Baseline Document Change Announcement

ANNOUNCEMENT: BDC18MB-01

SUBJECT: Appendix 3 – Guide Plates
- Revision to Plate 3.4-12 and addition of Plate 3.4-13 to the *Design Manual for Bridges and Structures, 6th Edition*

PLATE
3.4-12

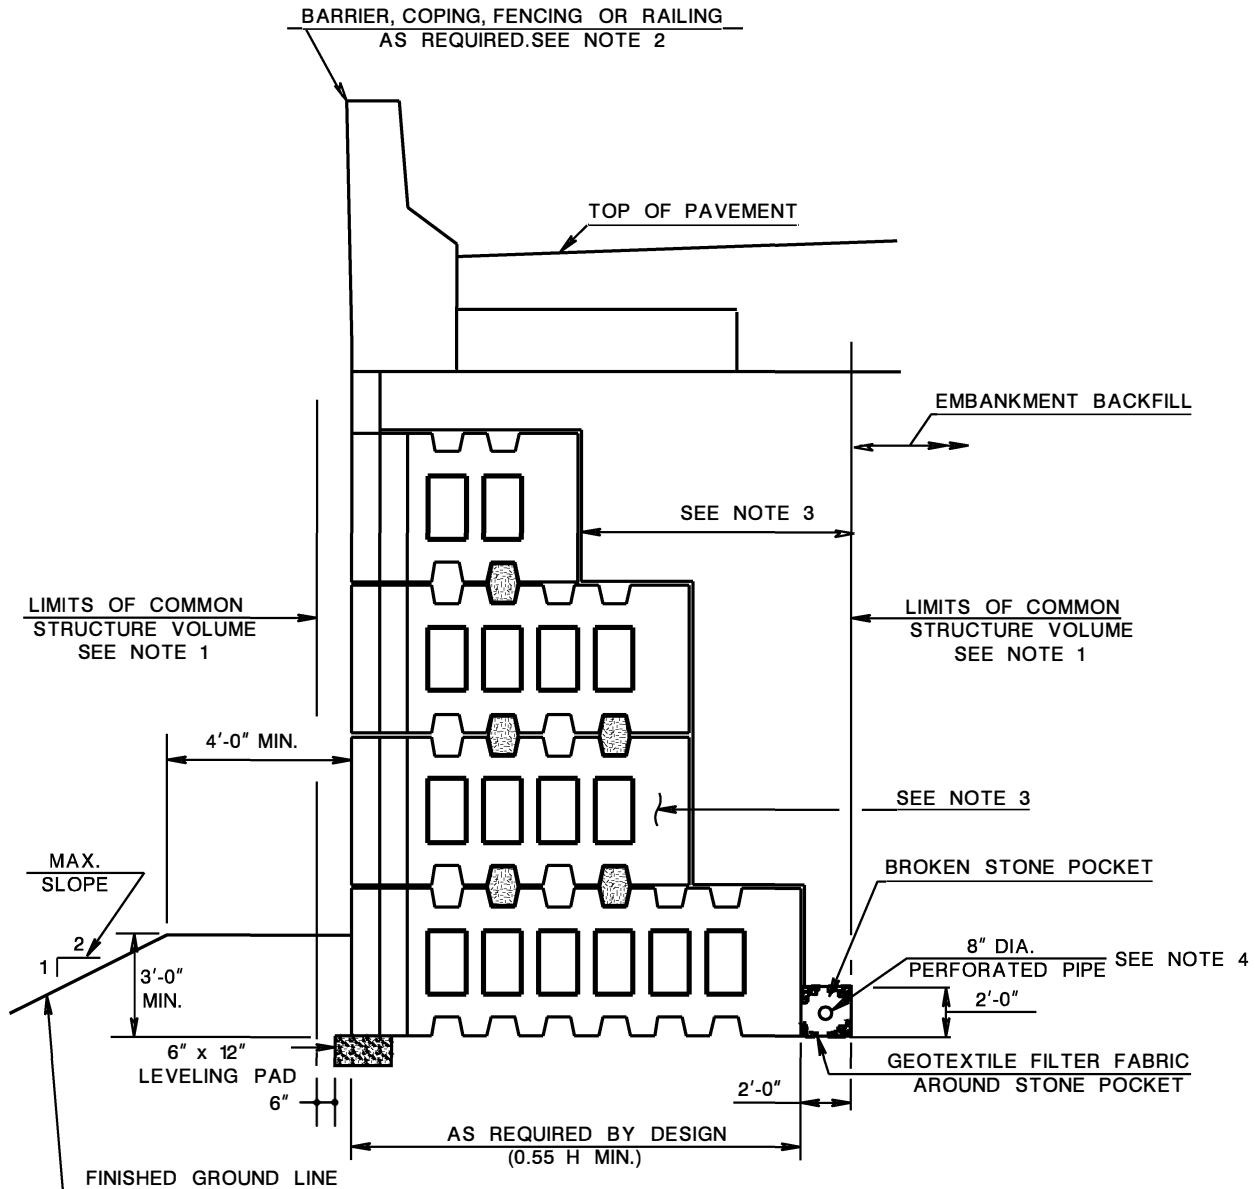
Appendix 3 Plate 3.4-12 “T-Wall Typical Section” has been revised to provide a note for when a drainage system is applicable in order to prevent the buildup of Hydrostatic pressure. Also, a new Plate 3.4-13 “Inverted T-Wall Typical Section” has been added to Appendix 3.

Plate 3.4-12 – Revised

- (1) THE LIMIT OF COMMON STRUCTURE VOLUME BEHIND THE WALL SHALL BE GOVERNED BY THE WIDEST LIMIT FOR FILL SECTION AND THE NARROWEST LIMIT FOR CUT SECTION OF ALTERNATE WALL ALLOWED IN THE CONTRACT AT THAT LOCATION. THE DESIGNER SHALL CONTACT THE WALL MANUFACTURER TO DETERMINE THE WIDTH OF THE NEEDED FILL.
- (2) PAYMENT FOR THIS ITEM IS BASED ON PROJECT TO PROJECT BASIS.
- (3) REFER TO THE NJDOT STANDARD SPECIFICATIONS AND SECTION 17 OF THIS MANUAL FOR PERMISSIBLE BACKFILL MATERIALS AND REQUIREMENTS FOR THE PLACEMENT OF GEOTEXTILE FILTER FABRIC MATERIAL.
- (4) DRAINAGE SYSTEM IS ONLY APPLICABLE WITH THE USE OF A NON-PERMEABLE BACKFILL MATERIAL (i.e. GEOFOAM, CONTROLLED LOW-STRENGTH MATERIAL, etc.) OR AN ENVIRONMENT SUBJECT TO EXCESSIVE FLOODING.

PLATE
3.4-13

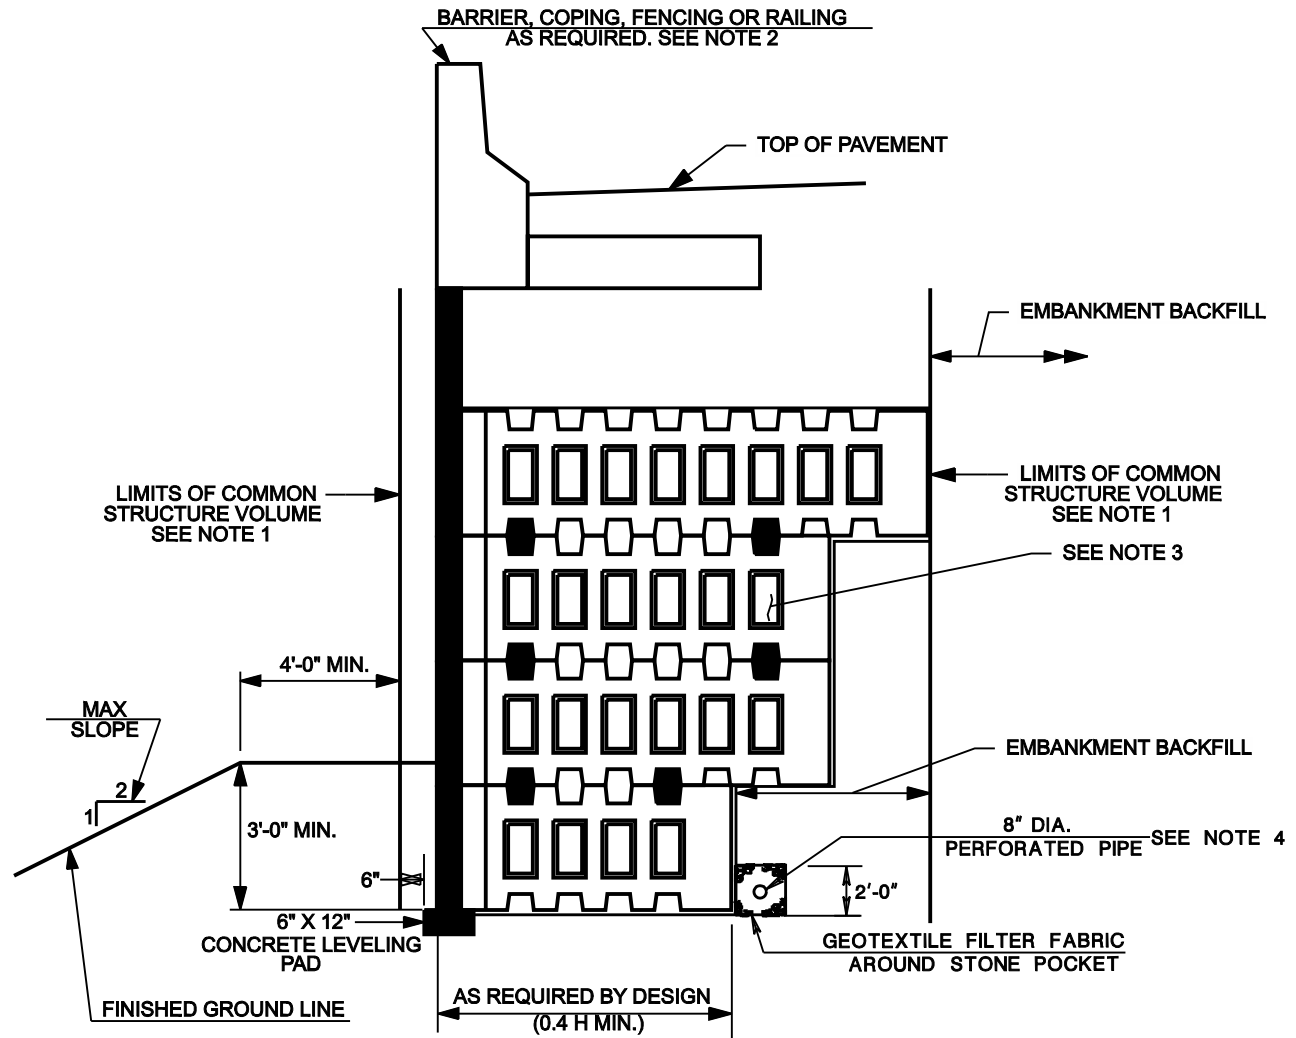
Plate 3.4-13 – New
